5. Lease Serial No. NMNM96231
6. If Indian, Allottee or Tribe Name
7. If Unit or CA/Agreement, Name and/or No.
8. Well Name and No. LOST TANK 33 11
9. API Well No. 30-015-29677-00-S1
10. Field and Pool or Exploratory Area DELAWARE LOST TANK
11. County or Parish, State EDDY COUNTY, NM

OXY USA Inc. - Proposed
Lost Tank 33 Federal #11
API No. 30-015-29677

**Permanent Abandonment of Federal Wells
Conditions of Approval (LPC Habitat)**

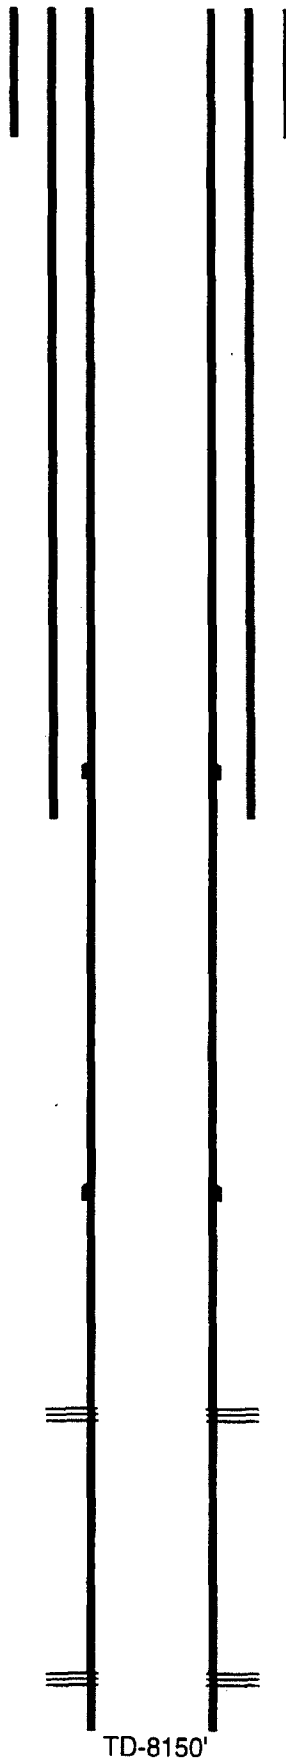
7. M&P 90sx cmt @ ~~4000~~ to surface *948-Surf.*
10# MLF between plugs
Above ground steel tanks will be utilized

90sx @ 1000' - Surface

T/Leat 898 +/-
B/salt 4077 +/-

Asht 3810

Det. time 4107

OK 1-22-18 "Secretary's Potash"
Accepted for record - NMOCD
Solid Plug not RequiredRECLAMATION PROCEDURE
ATTACHEDSEE ATTACHED FOR
CONDITIONS OF APPL
